ORIGINATION FORM

Proposed Revisions to a Standard Plans Index

Index Number: 649-020

Index Title: STEEL CCTV POLE

LAST REVISION		DESCRIPTION:	FDOT FY 2023-24 STANDARD PLANS	STEEL CCTV POLE		INDEX	SHEET
11/01/22	11/01/23					649-020	1 of 6

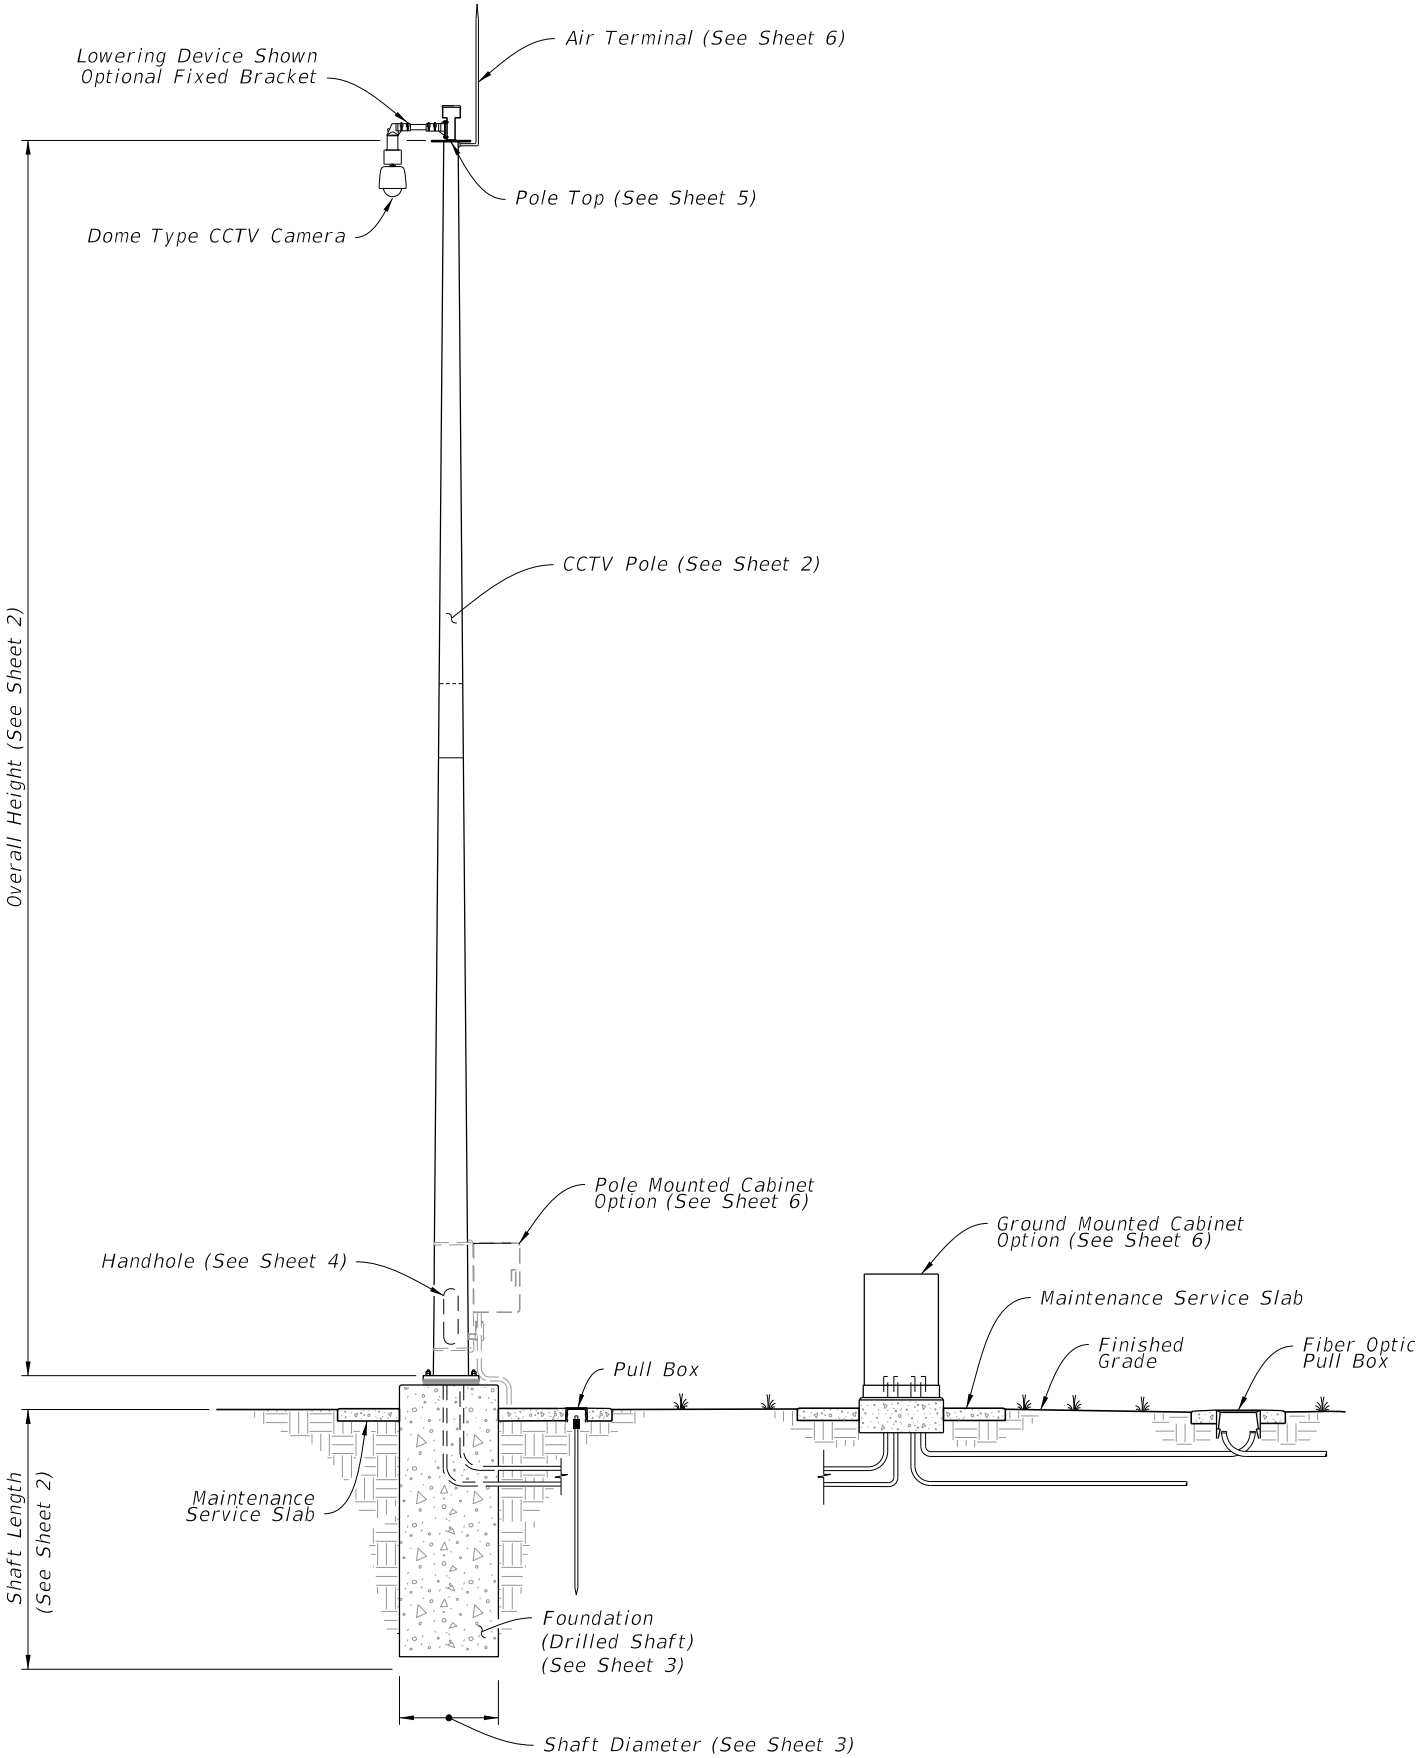
Sheet 1: Changed phrase from "full-penetration groove" to "complete joint penetration.

Sheet 1: Changing non-standard language to standard language consistent with AWS.

1. Use a ~~full-penetration groove weld~~ within 6 inches of the circumferential tube-to-plate connection and

2. Use ~~full-penetration groove welds~~ on the female end section of telescopic (i.e., slip type) field splices for a minimum length of one and one-half times the inside diameter of the female section plus 6 inches.

LAST REVISION		DESCRIPTION:	FY 2023-24 STANDARD PLANS		STEEL CCTV POLE	INDEX	SHEET
11/01/21	11/01/23		FDOT			649-020	4 of 6

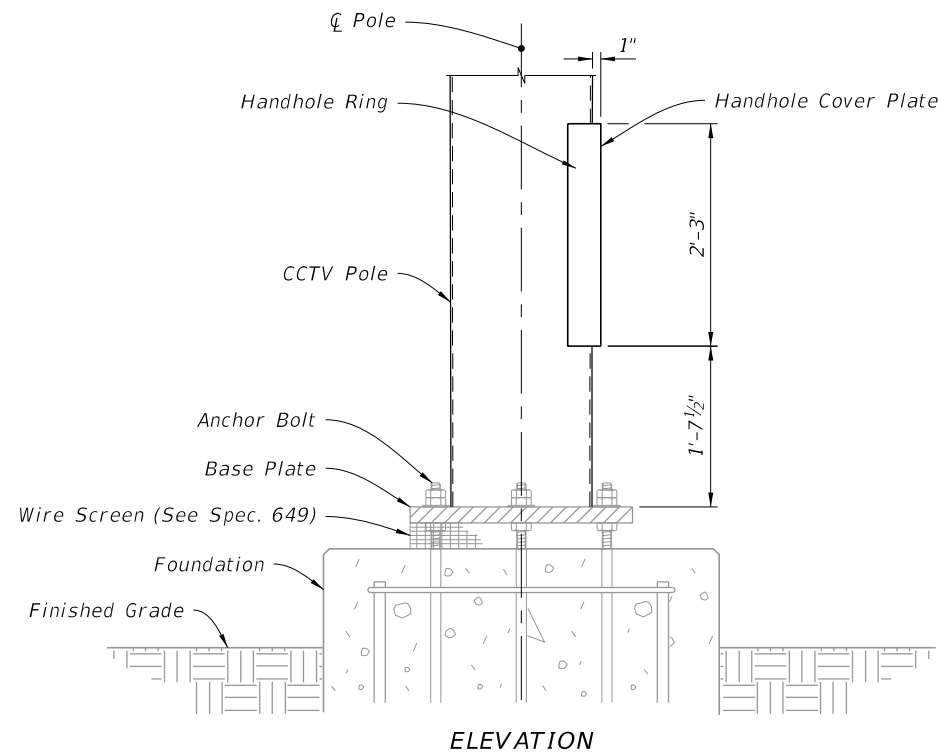
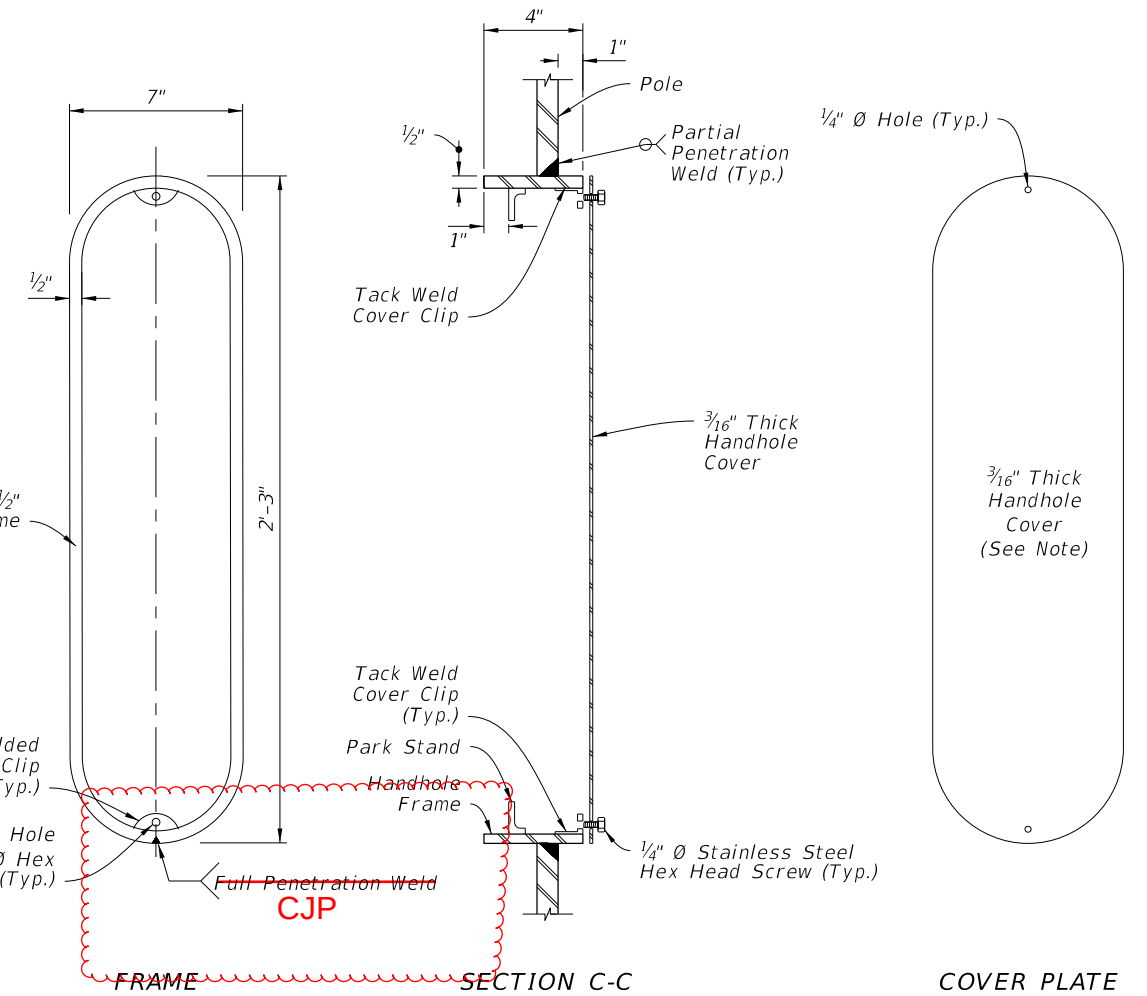
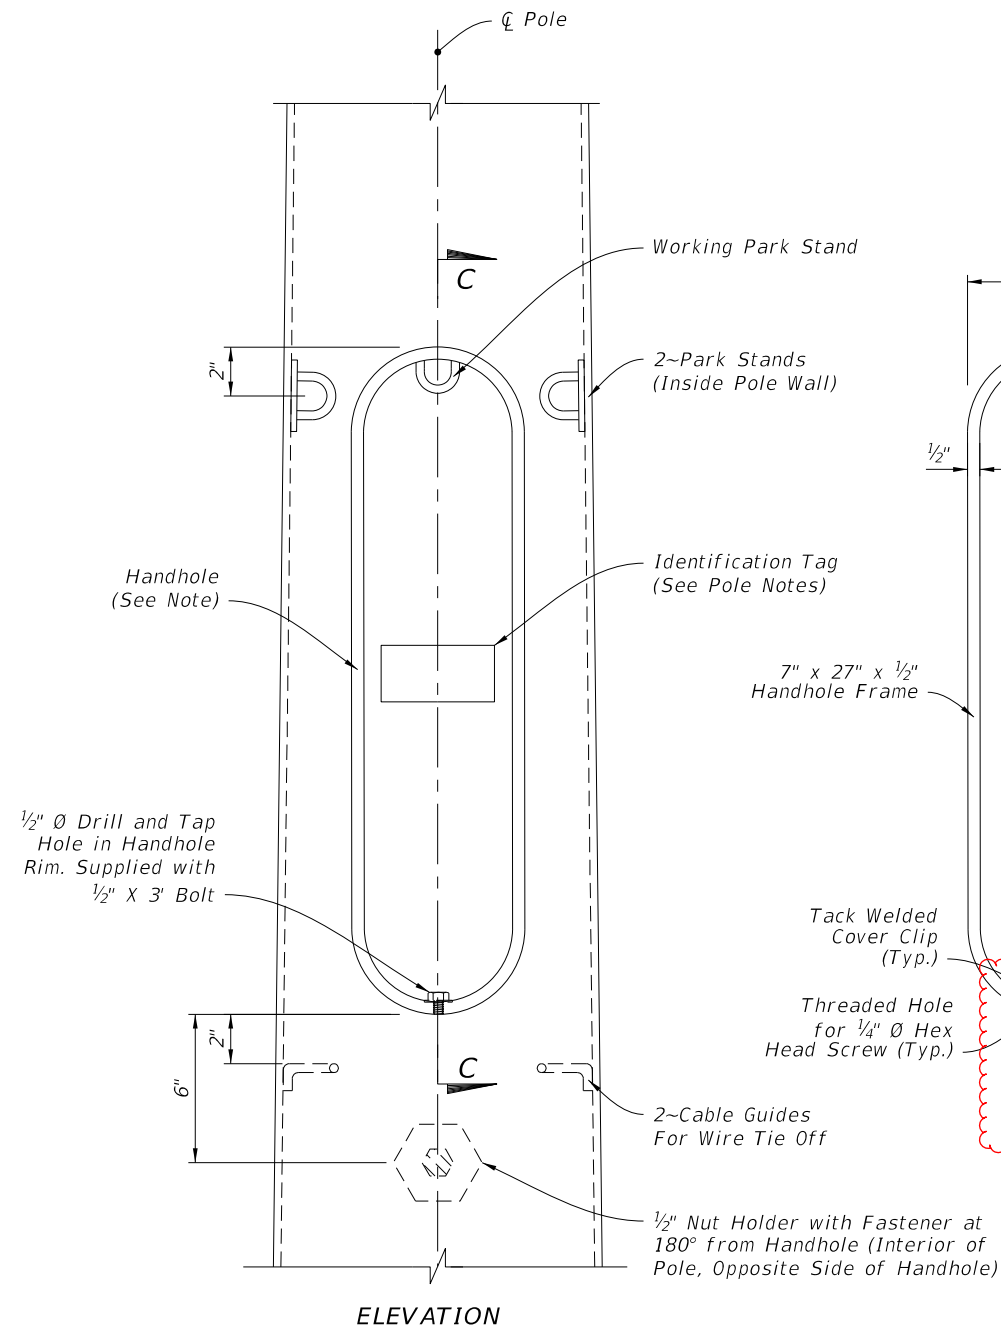
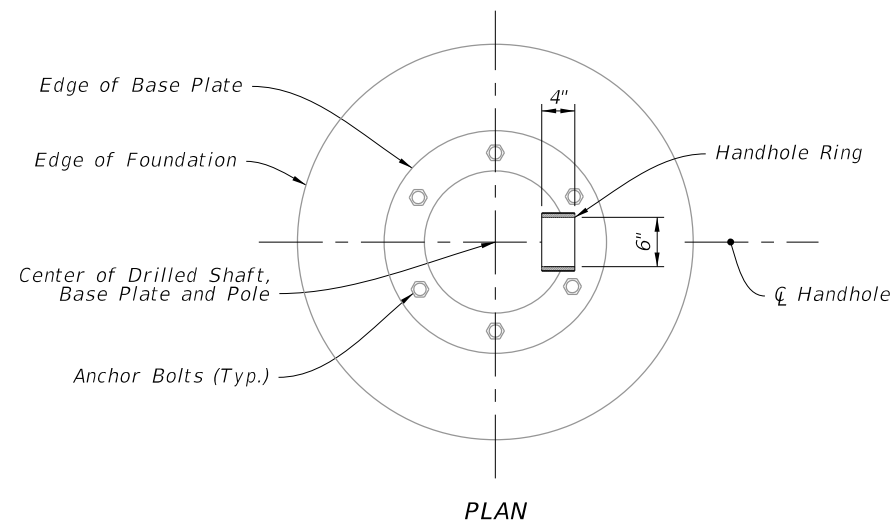
Sheet 4: Changed weld detail to say "CJP."

Sheet 4: Changing non-standard language to standard language consistent with AWS.
